ATS token timing

Mick Seaman

2. Recommended P802.1Q-Rev changes

Figure 1-1—BucketEmptyTime and tokens

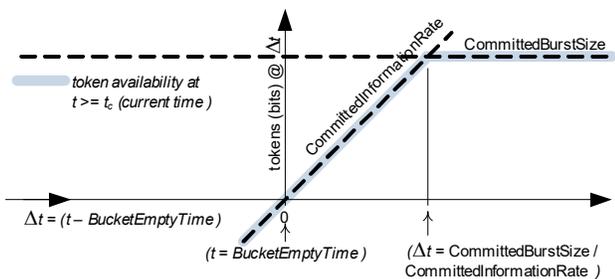
Figure 1-1 illustrates the relationship between these two ways of expressing the scheduler’s state.

The scheduler state is only the current picture of token availability, even when scheduler eligibility at other

Figure 1-2—An historical account

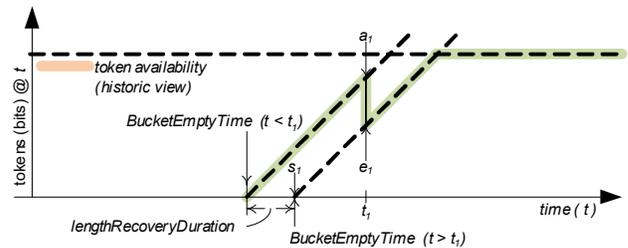
times is considered. It, and Figure 1-1, is not a historical record. In Figure 1-2, for example, a frame that does not exhaust the immediately available supply of tokens has arrived and been scheduled as immediately eligible for transmission at $a_I = t_I = e_I$, and *BucketEmptyTime* updated appropriately.

The notional token bucket **was not empty** at the updated *BucketEmptyTime*,⁴ and an implementation which attempts to record that time by detecting a zero condition for a token count will not perform correctly.

Figure 1-3—Token debt

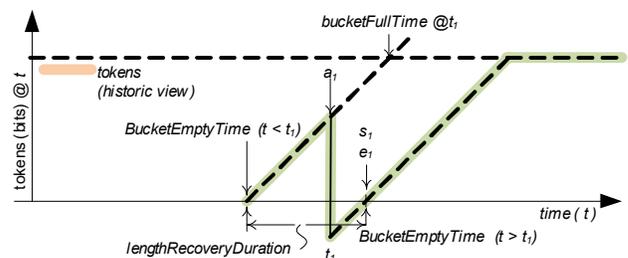
Negative token counts accommodate scheduling at a future time when the count has recovered sufficiently to accommodate a frame’s length as in Figure 1-3.

Figure 1-4—Spending while in debt

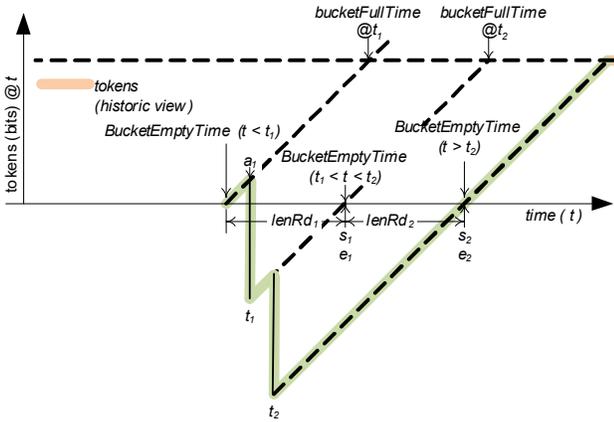
A number of frames can arrive, and can be eligible for transmission before the token count becomes positive again, just as long as sufficient tokens have been

added to the bucket between the successively updated *BucketEmptyTimes*. See [Figure 1-4](#).

Figure 1-5—Draw from the current account

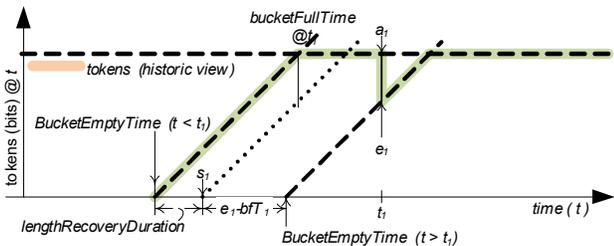
If a stream has been idle for a while, not using its *CommittedInformationRate*, the scheduler might process a frame and calculate a *schedulerEligibilityTime* that is in the past, before the frame arrived. If a stream was allow to spend unused past tokens it could exceed the committed burst rate, so the *eligibilityTime* is constrained to be no earlier than the frame’s *arrivalTime*, and the *BucketEmptyTime* adjusted ([Figure 1-5](#)) effectively using current tokens.

Figure 1-6—Group spending up front

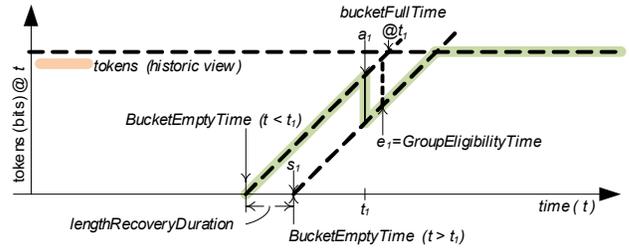
If the ATS scheduler is part of a scheduler group, a frame’s *eligibilityTime* can be delayed past its *arrivalTime*, even if the scheduler had an ample supply of tokens at that time. The calculated update to *BucketEmptyTime* has the effect of subtracting the necessary tokens at the *arrivalTime*. If the scheduler processes no more frames before the *eligibilityTime* is reached, the resulting number of tokens will be the same as would result from delaying the reception of the processed frame to that time. In [Figure 1-6](#) the calculated *eligibilityTime* is before *bucketFullTime*, sufficient tokens to process the frame are already available, and the number of tokens apparently removed from the bucket corresponds to the length of the processed frame. In [Figure 1-7](#) and [Figure 1-8](#) the updated *eligibilityTime* is after *bucketFullTime*, and the adjustment to *BucketEmptyTime* necessary for the token count at that *eligibilityTime* to reflect the remaining burst capability

appears as a token count reduction at the arrival time in excess of that dictated by the frame’s length.
